CHANGE ORDER

Change Order Number 02

Project Garage Membrane

Recommended Landscaping Changes & Underground Parkade Vents

Site Photos – Existing Cracked Concrete Blocks

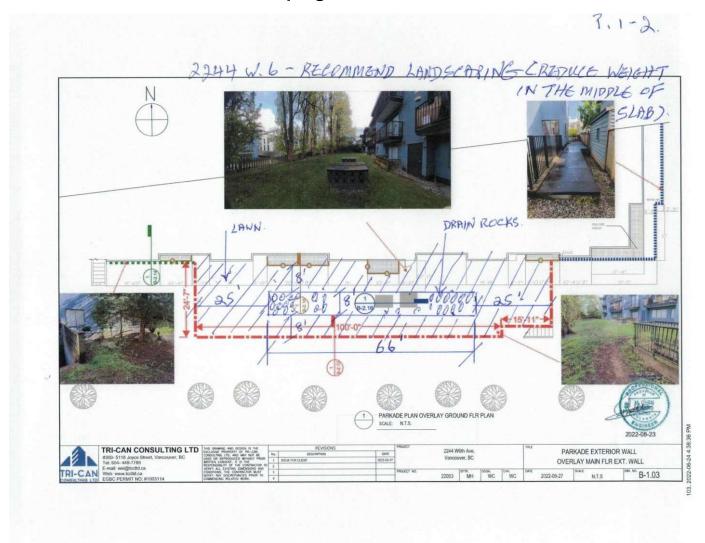
The other concern is the parkade vents. As shown in the pictures below, the existing architectural concrete blocks are visibly loose, coming apart and are in dire need of repair. In their current condition the concrete blocks are not structurally sound and will likely crack

when the new aluminum louver vents are mounted onto them. To avoid further repair costs, we recommend the immediate replacement of the architectural concrete blocks with treated timber material, which will work better to mount the new louver vents at the four sides.

2.	Existing concrete blocks are not structurally sound & will most likely crack more when mounting new aluminum louver vents.	
3.	Remove & dispose of all architectural concrete blocks and rebuild perimeter with treated timber and top horizontal surface with cricket for shedding water.	
Add 1	additional New Floor Drain:	\$900.00
	Cored fifth, 4" hole (low point - necessary for rain water to drain off) through the concrete slab for 3" floor drain.	ψοσο.σο
	Supplied & installed 3" spun copper floor drain. Supply & connect new drain with ABS pipe to SOG.	
Appe	ndix E – Ship Soil Off:	
	There is a \$30,760.00 budget in the CCDC2 contract allocated for shipping the soil off site & replace with new.	(\$14,900.00)

Recommended Landscaping Sketches

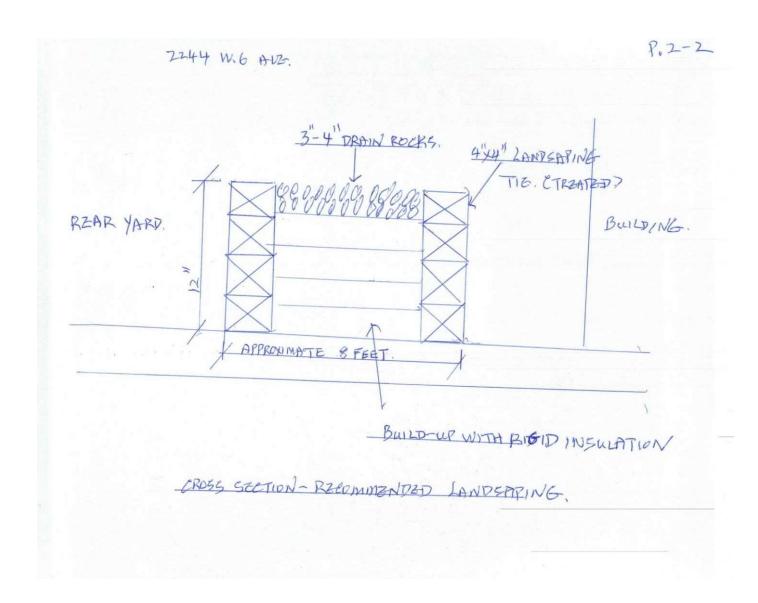
Description	Estimate
Reco	mmended Landscaping Design Changes:	\$11,500.00
	Please see the attached (on next page) the Landscaping Sketch recommended by Flagship Construction, which reduces a lot of dead load in the centre of the concrete slab as per the Structural Engineer recommendation.	· ,

2.	Right in the centre of the concrete slab – approximate 8 feet x 66 feet area to be surrounded with 4" x 4" of landscaping tie, built up with ridge insulation & complete with 3" – 4" of drain rocks.

3.	The remaining areas are still to be re-landscaped with lawn (new seed).	
Parka	de Vents:	\$2,500.00
1.	Existing concrete blocks are loose, coming apart & need repair.	, ,
